Highways Committee
20th January 2008

Report Title: Petition against the Kingsbury Road Local Safety Scheme

Kingsbury Road - Local Safety Scheme (Valley Drive to Roe Green)

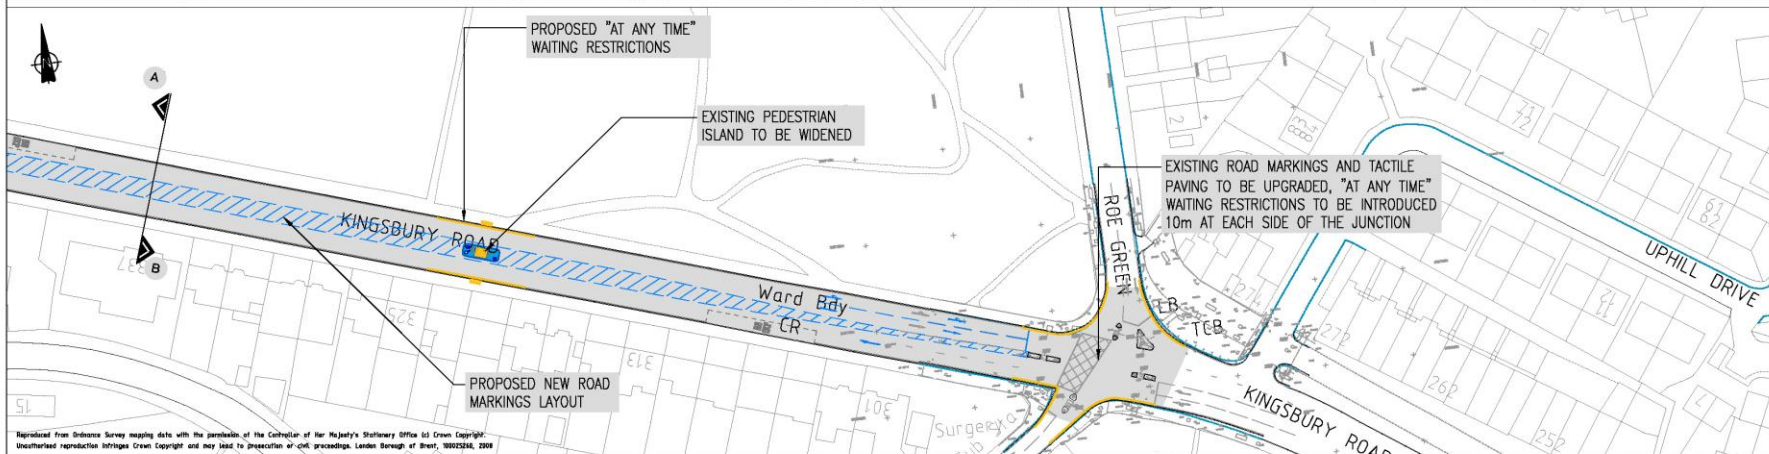
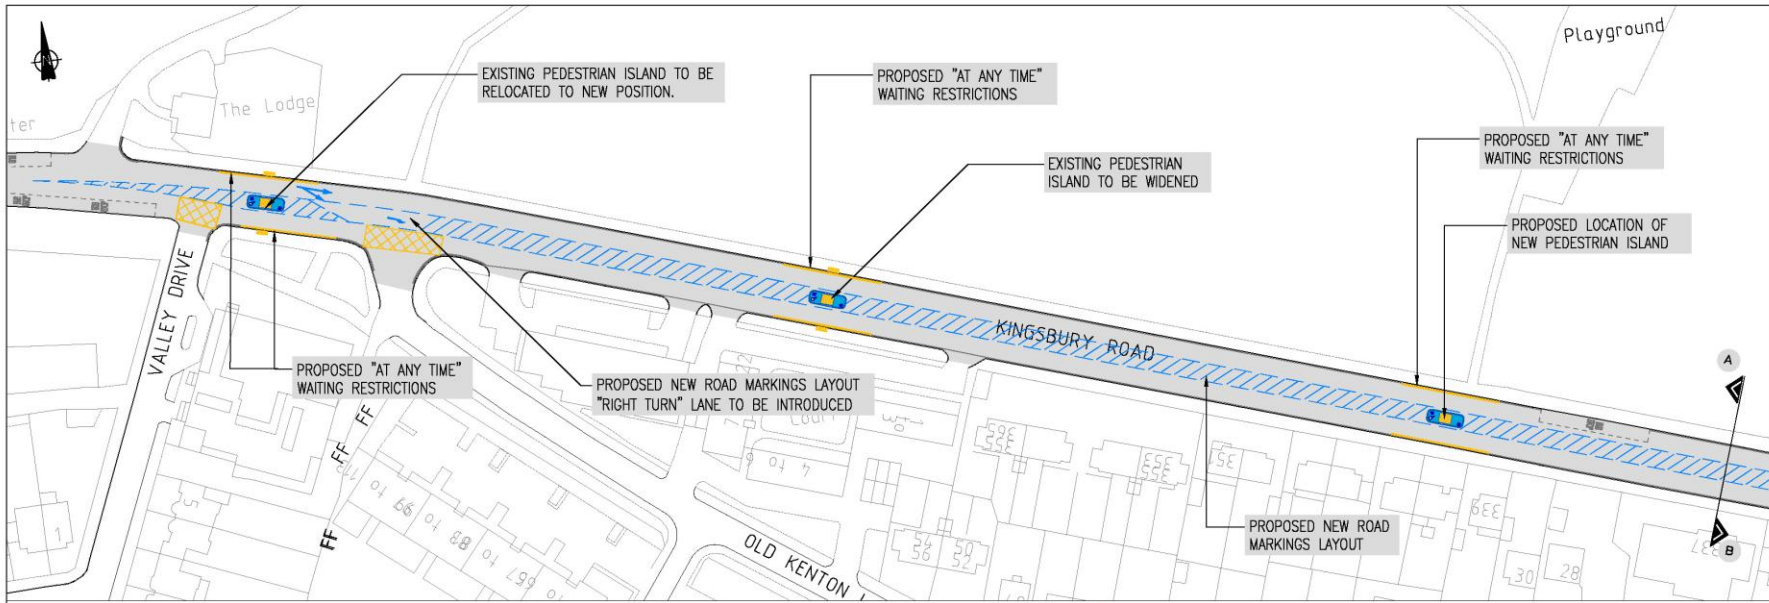
Residents		
	Kingsbury Road	<ul style="list-style-type: none"> • Narrowing Kingsbury road for vehicular traffic will increase traffic and congestion in the area.
	Kingsbury Road	<ul style="list-style-type: none"> • Those currently using Roe Green park can currently

park their cars on Kingsbury Road adjacent to the park, but when the road is changed to single lane this facility will not longer be available as a consequence they will have to park on nearby roads.
	Kingsbury Road	<ul style="list-style-type: none"> • Making Kingsbury Road to one lane in each direction will only increase congestion besides that visitor to residents will not be able to park.
	Kingsbury Road	<ul style="list-style-type: none"> • Agrees with the provision of traffic islands but can not see any benefits to narrowing Kingsbury Road apart from holding up the traffic even more.
	Kingsbury Road	<ul style="list-style-type: none"> • Night time traffic will move nearer to our homes, vibration and noise is a problem now, when vehicles are another lane close to our homes it will be worse.
	Kingsbury Road	<ul style="list-style-type: none"> • At least having 2 lanes people could turn left into Old Kenton Lane or Valley Drive without waiting in the long queue into Kingsbury shopping area and also turning left out into the Kingsbury Road.

Kingsbury Road	<ul style="list-style-type: none"> • The scheme will cause parking difficulties for visitors.

- Gary Pidgeon (Metropolitan Police) in representation of some residents of the area argues that the amount of accidents in the study area does not justify the need for traffic calming or speed reduction measures, in addition suggest that some of the accidents are not speed related. Also thinks that reducing the two lanes to one lane proposal will create holds ups and tail backs for traffic. *Brent Council's prioritise location for remedial measures based o the number of accidents occurred in the last three years Kingsbury Road has been identified as a high priority spot for a local safety scheme.*
it is apparent from site observations and the result of speed surveys, which indicates that 85 percentile speeds are around 40mph this and the existing road layout are a key contributing

- Julia Day chairperson of the Valley Farm residents association is against the new proposals for Kingsbury Road arguing that it will make things worse as Kingsbury road already gets jammed, having one lane in each side of the road will stop people wanting to turn left into Old Kenton Lane or Valley Drive adds that parking along the road will be lost and will make the situation more difficult for the surrounding roads. *As already mentioned enough 2 lane stacking space will be maintained at the Roe Green signal, it is possible at peak times that the scheme will lead to an increase on queue lengths as cars may be stacking in one lane for part of the queue length instead of two lanes, although this will not impact on the number of cars queuing or their journey time. Parking restrictions are proposed to change to "at any time" waiting and loading near the pedestrian islands (10m each side approximately) the remaining part of Kingsbury Road will maintain the existing waiting and loading restrictions in place and will accommodate the existing parking activity.*

- 5.1 Results of the consultation can be found in Item 4.2
- 5.2 Some residents raised their concerns on the effect that the scheme will have on congestion, the main constraints to traffic movements in the area are the Roe Green signals and the nearby Kingsbury Roundabout, Sufficient 2 lane stacking space will be maintained at the Roe Green signals in order that their capacity will not be affected. It is possible at peak times that the scheme will lead to an increase in queue lengths as cars may be stacking in one lane for part of the queue length instead of two lanes, although this will not impact on the number of cars queuing or their journey time.

- 5.3 A number of comments were received with regard to the loss of parking along the area of the scheme. The proposed new lane width is 4.3m each direction with a further 4.0m wide central hatching allowing enough space for cars to be parked on both sides of Kingsbury Road with not negative effects on traffic flow. At any time waiting restrictions will be implemented 10m at each side of all pedestrian islands to allow free flow for buses.

- 5.5 Residents of Valley Drive expressed concerns about delays for them accessing the area as cars currently queue in the outside lane allowing the nearside lane for residents to use it to gain access to Valley Drive and Old Kenton Lane, although queue lengths have not been observed extending this far, it has been agreed to widen the traffic lanes on the approach to the Junctions of Old Kenton Lane and

Valley Drive which will maintain enough road width in order to allow space for vehicles travelling westbound to turn left into these roads.

Following on from the meeting on 18th November 2008 between Council Officer and Ward Councillors the scheme design has been amended to include space for two lines of traffic on the westbound side of the road starting just before Old Kenton Lane and running up to Valley Drive, this will provide the space for left turning motorists to access Valley Drive. It is also intended to include a marked right turn facility into Valley Drive from Kingsbury Road.
